T10/04-383r0

To
INCITS T10 Committee

From
Michael Banther, HP

Subject
FCP-3 Clarification to TPRLO

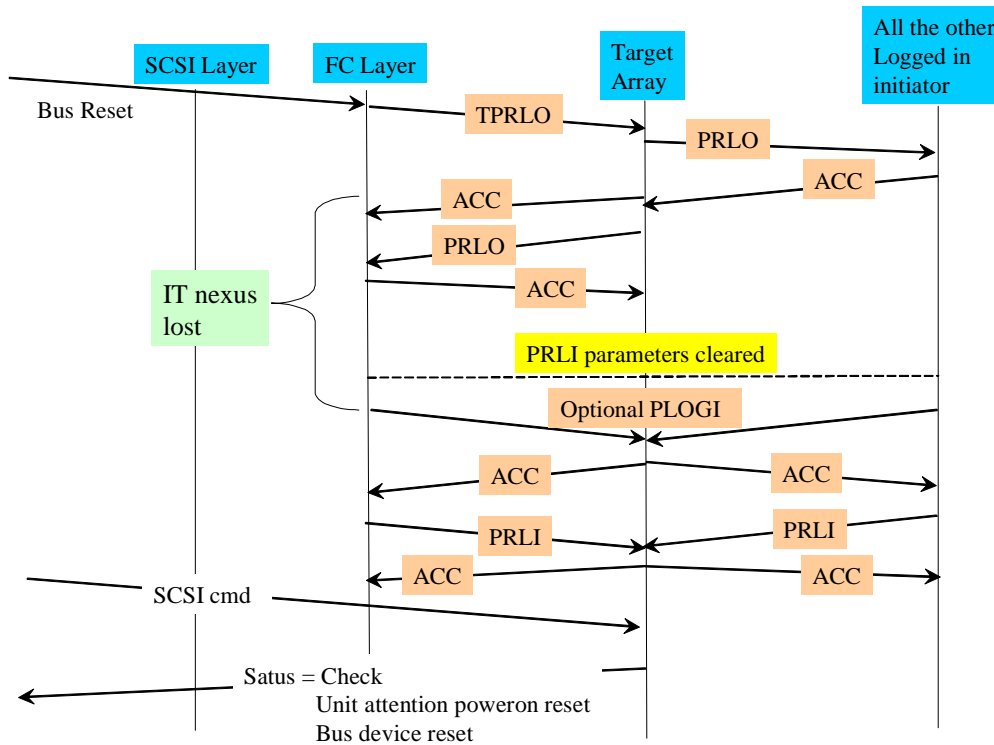
HP has become aware that some target devices do not log out all initiators during a Third Party Process Logout when the GLOBAL bit is set to one. This behaviour results in PRLI parameters remaining set. HP believes that the diagram below shows the correct behaviour.

- 3 For TPRLO (Third Party Process Logout), actions listed **under PRLI/PRLO** shall be performed **for all initiators** when the GLOBAL bit is set to one. If the GLOBAL bit is set to zero, then the actions listed under PRLI/PRLO shall be performed for the designated initiator. See FC-FS.
